AS BUILT PLANS
Contract No. 04-036804
Date Completed 5-14-91
Document No.

CONTRACT CHANGE ORDER NO. 11
SHEET 13 OF 152

SFOBB TOLL PLAZA MODIFICATIONS
CONCRETE & MASONRY STANDARD

Job Stamp	Detail
[illegible]	Sidewalk details for SFOBB Toll Plaza CCO # 29
Drawn By Jeff Abercrombie	Date 3-5-87
Checked By	Date

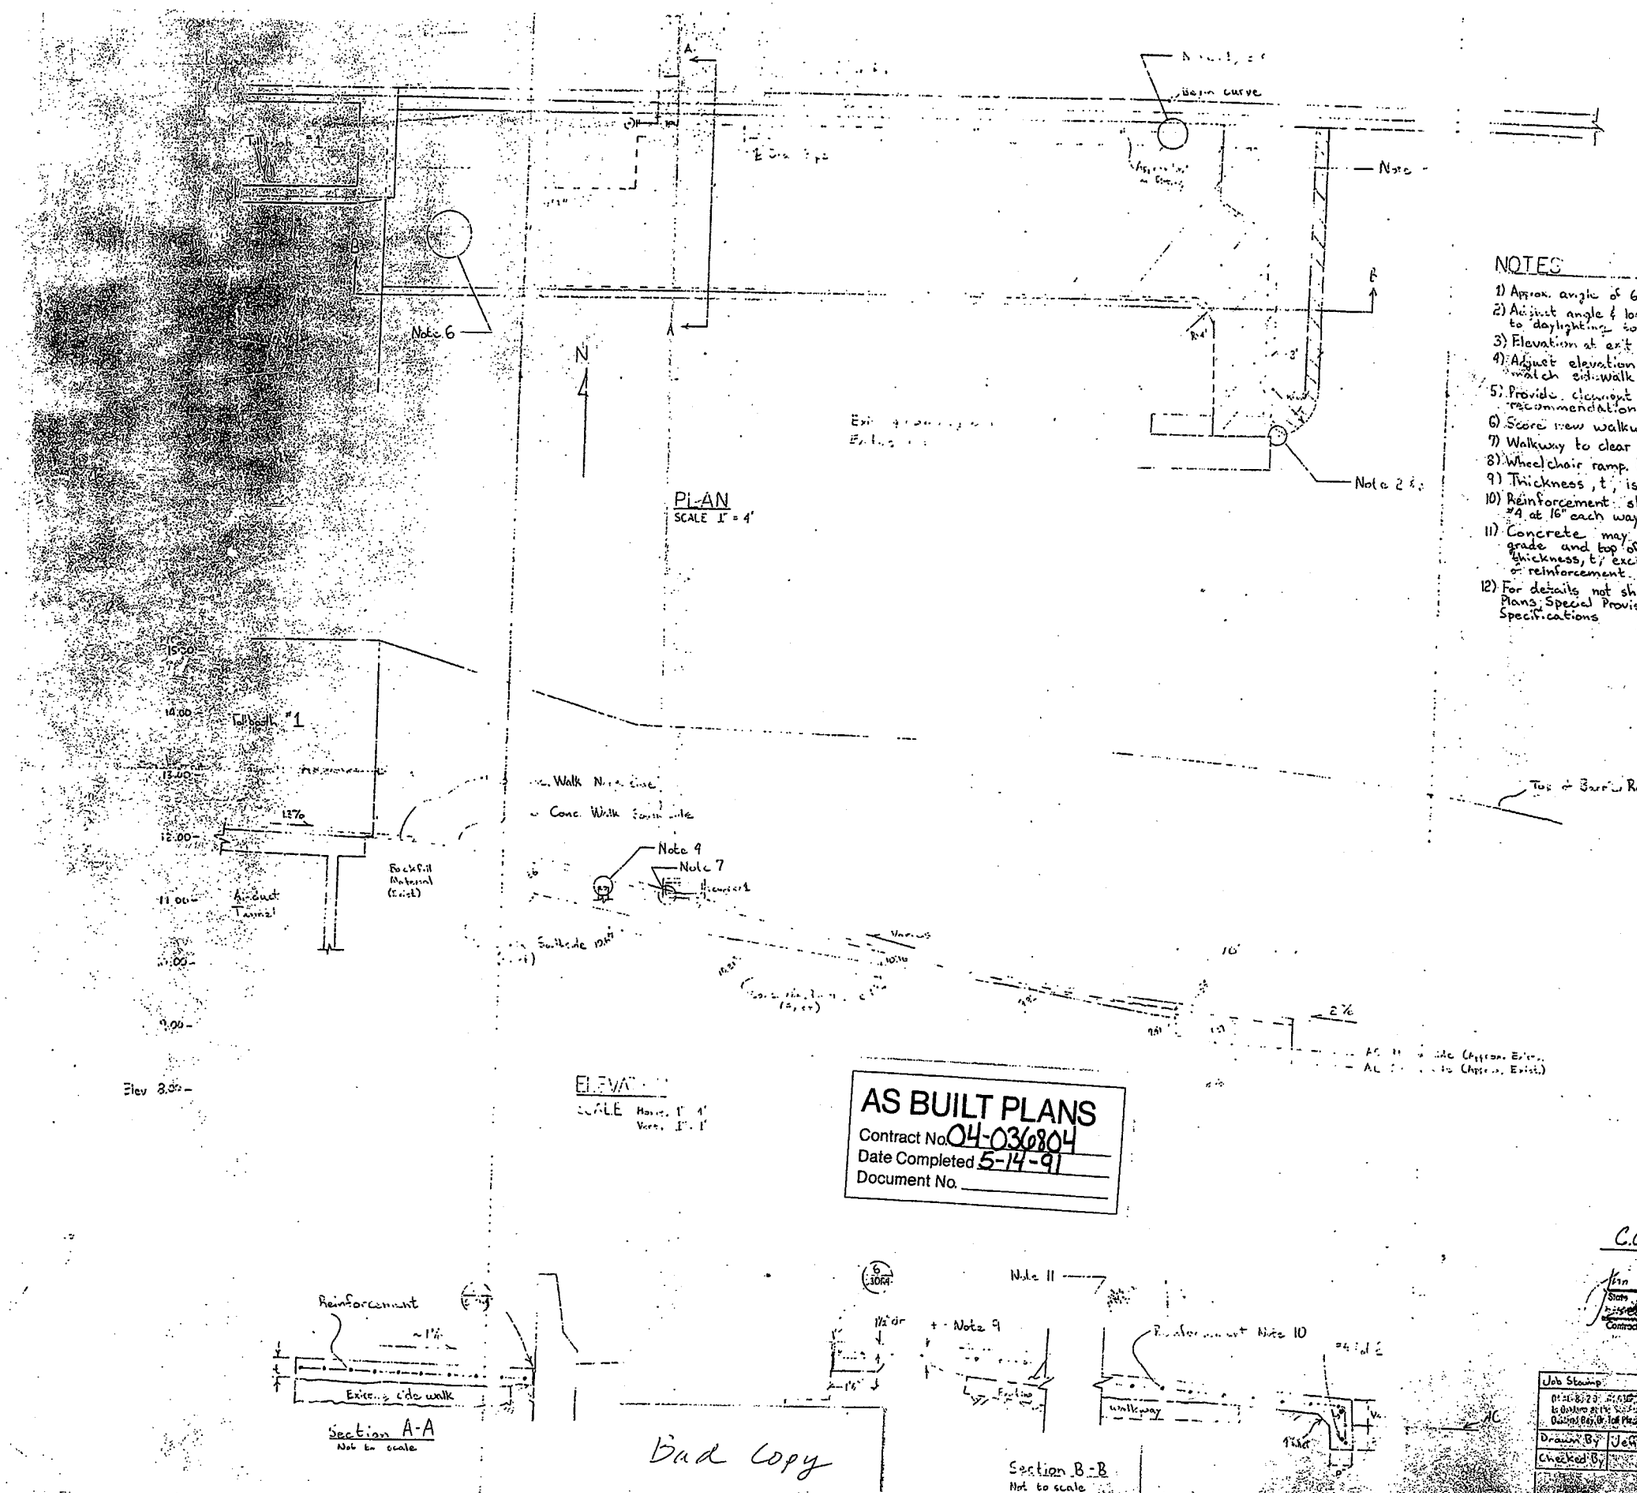
1) Approx. angle of 67°
2) Adjust angle & location of [illegible] to daylighting to clear existing lower walk
3) Elevation at exit shall match exist. AC
4) Adjust elevation of cleanout to match sidewalk
5) Provide cleanout based on code or recommendation
6) Score new walkway at approx. 3' intervals
7) Walkway to clear scuppers
8) Wheelchair ramp. Refer Standard Details N8-B
9) Thickness, t, is 3½" minimum
10) Reinforcement shall be 4x4-W4.0 x W4.0 or #4 at 16" each way - See Note 1
11) Concrete may be use between finish grade and top of existing walkway. If thickness, t, exceeds 5½" two layers of reinforcement is required
12) For details not shown refer to the Contract Plans, Special Provisions & Standard Plans and Specifications

SFOBB TOLL PLAZA MODIFICATIONS
BEAM SUPPORT PEDESTAL AT BENT 2

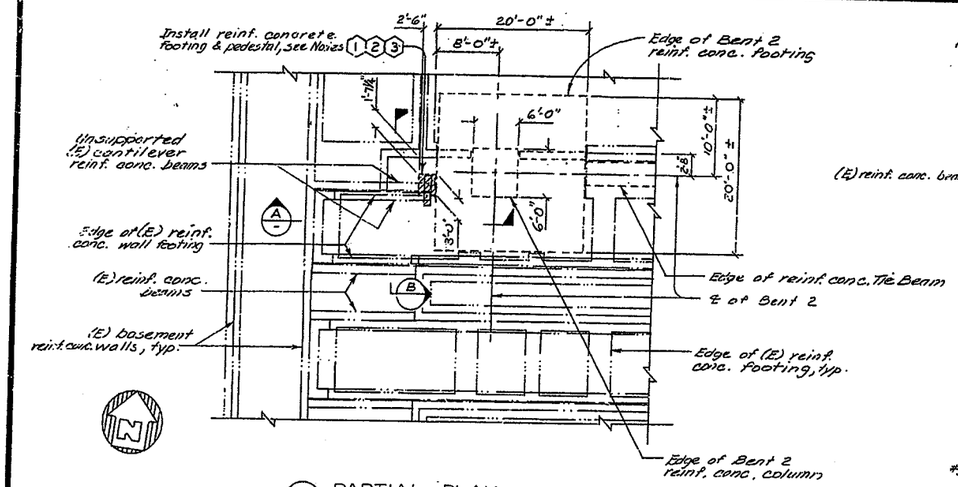
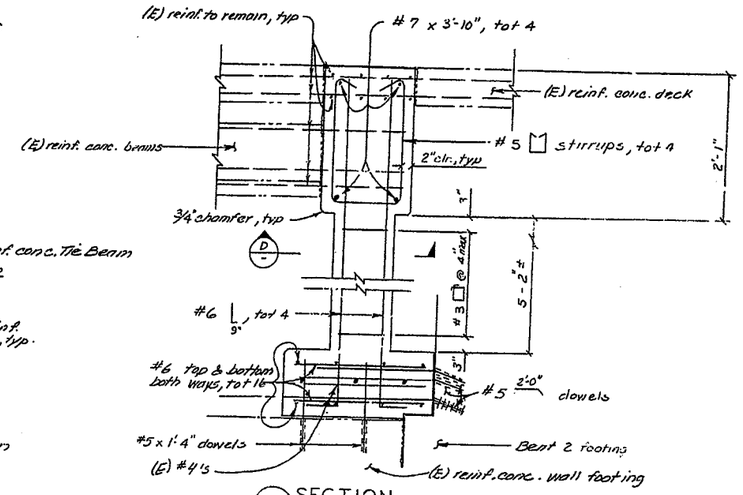
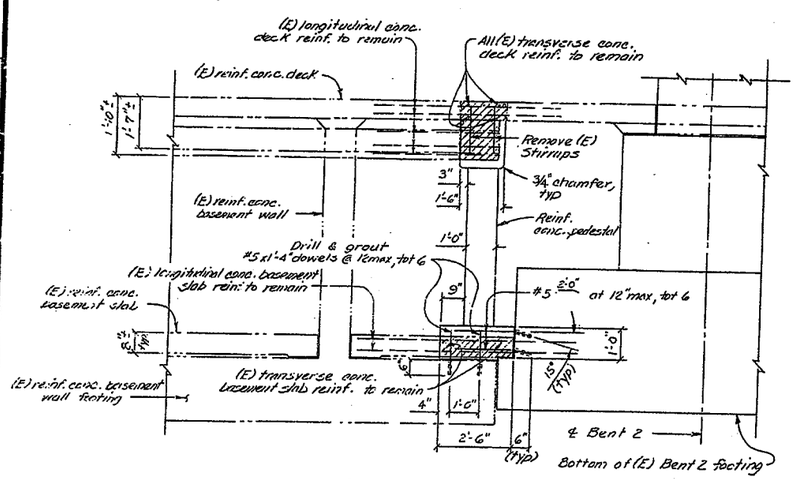
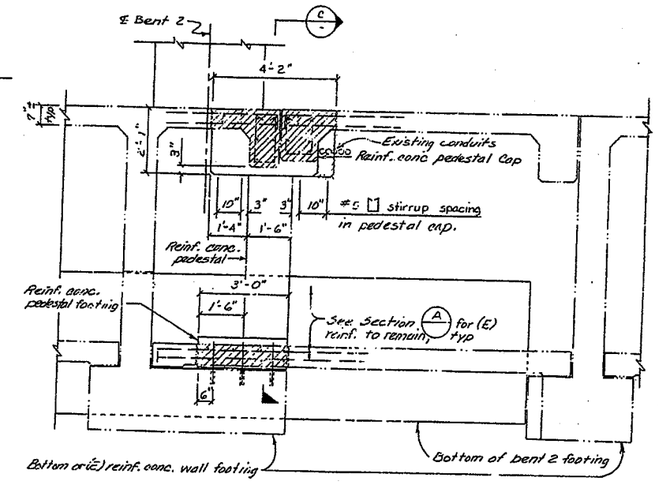
1. Remove 2'-6" x 3'-0" portion of (E) basement concrete slab and 1'-6" x 4'-2" portion (E) concrete deck, (E) reinforcement to remain undamaged, typ.
2. Drill and grout #5 dowels into the (E) reinforced concrete wall footing & in the (E) Bent 2 reinforced concrete footing as shown in Section A.
3. Install 2'-6" x 3'-0" reinforced concrete footing, install 1'-0" x 1'-0" reinforced concrete pedestal, and install 1'-6" x 4'-2" reinforced concrete pedestal cap.
4. Indicates limits of (P) reinforced concrete removal.
5. Indicates existing structure.

(11) REVISED JOINT DETAIL △

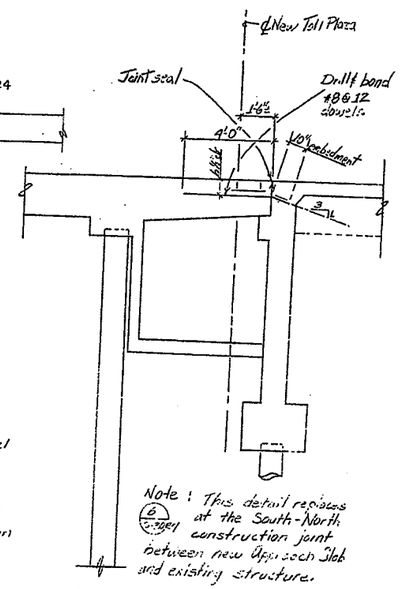
Note: This detail replaces (6) 3/530-24 at the South-North construction joint between new Approach Slab and existing structure.

△	Revised joint details per C.C.O. 33	D.L.E. 7/25/96

SFOBB TOLL PLAZA MODIFICATIONS
TOLL BOOTH BASE DETAILS 2S

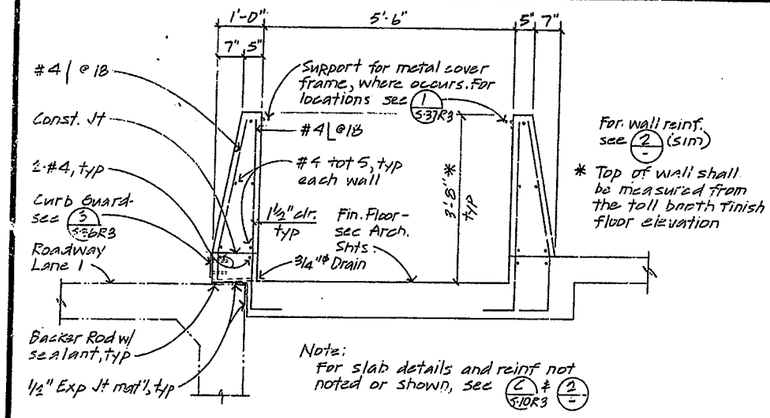
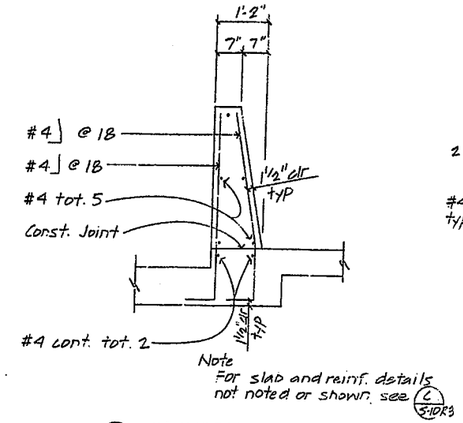
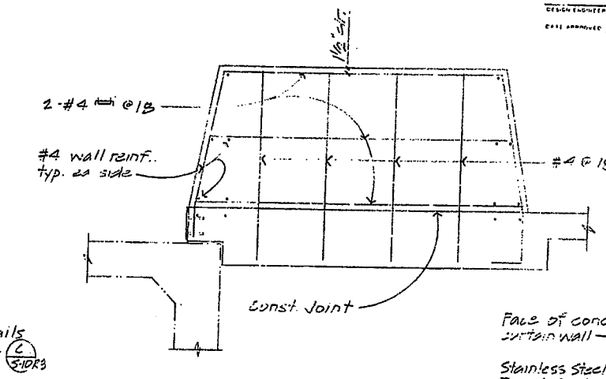
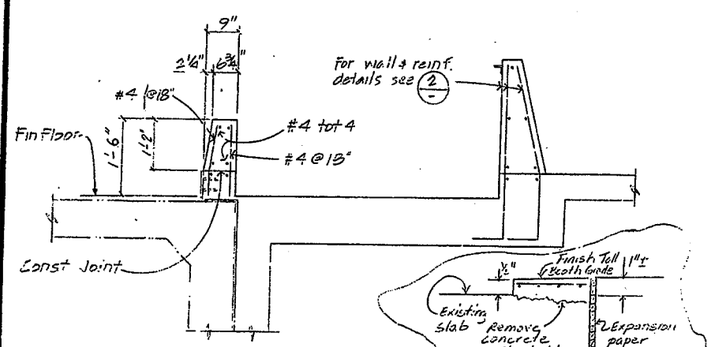
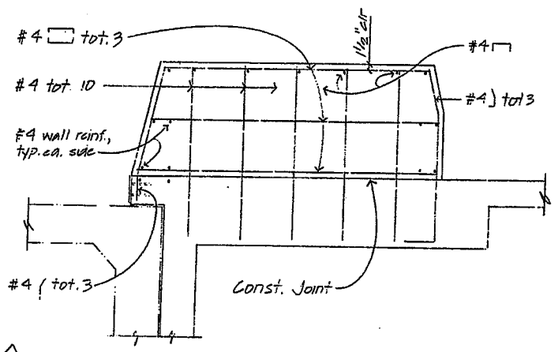
1	Revise TB.2 Per C.O.O. #24

SFOBB TOLL PLAZA MODIFICATIONS
NEW STAIRWAY NO. 7 DETAILS 1

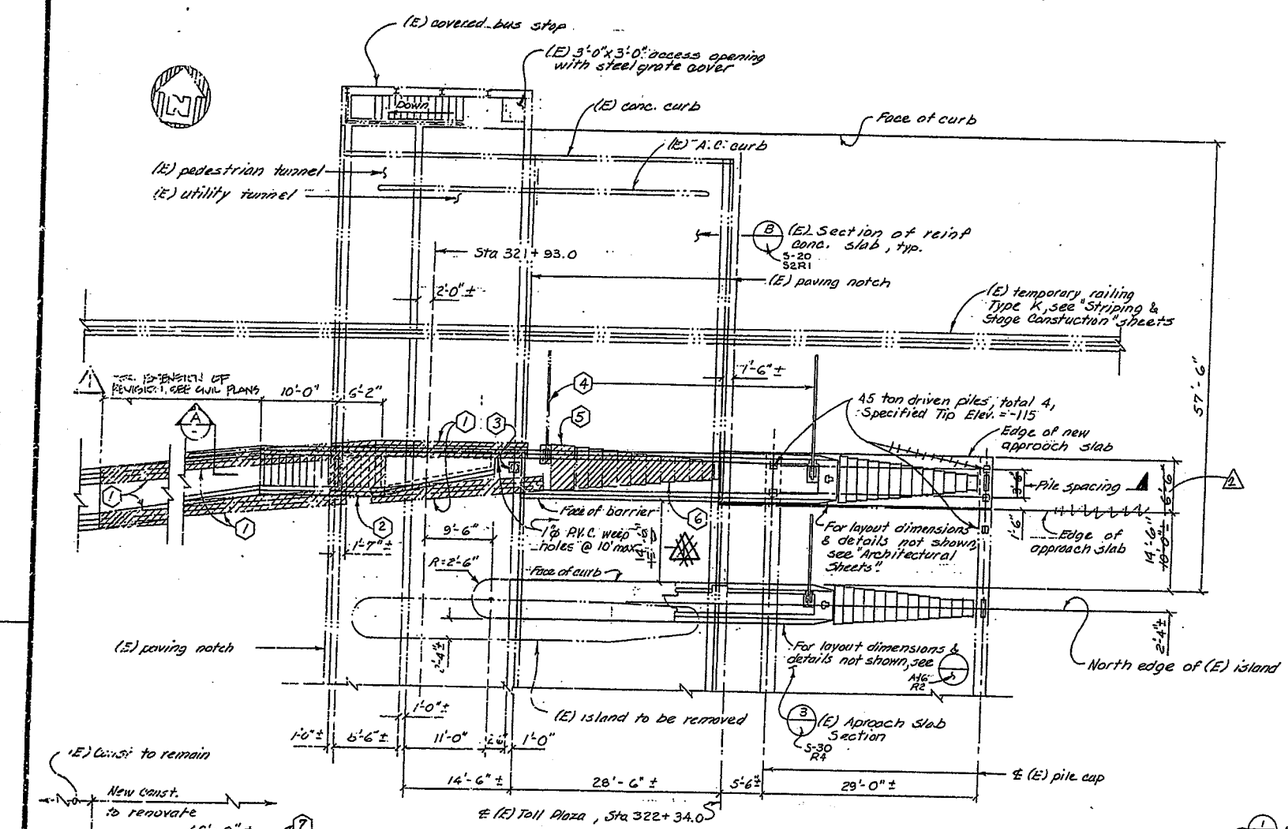
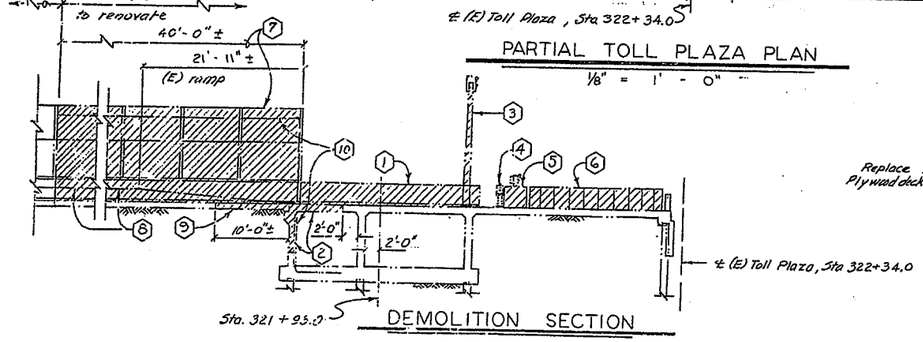
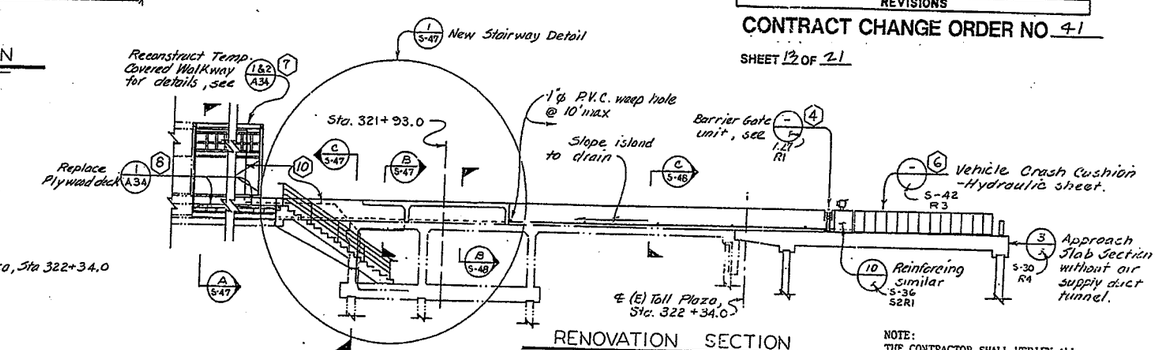
1. Remove (E) temporary concrete barrier Type 50.
2. Remove a portion of the (E) pedestrian tunnel concrete exterior wall and concrete deck. Retain existing reinforcement to remain undamaged, cut and bend as shown in the details on sheets "S-47" & "S-48".

3. Remove and salvage the (E) traffic signal.
4. Remove and relocate the (E) barrier gate unit.
5. Remove (E) reinforced concrete barrier.
6. Remove and relocate the (E) vehicle crash cushion - hydraulic.

7. Remove and reconstruct a portion of the (E) temporary covered walkway, see "Architectural" sheets.
8. Remove and reconstruct a portion of (E) wood ramp.

9. Remove a portion of (E) asphalt concrete pavement to construct the new reinforced concrete stairway.
10. Remove and relocate portion of (E) electrical lighting conduits for reconstruction of temporary covered walkway. Cast portion of electrical lighting conduits in the stairway wall and concrete barrier, see Electrical sheets.
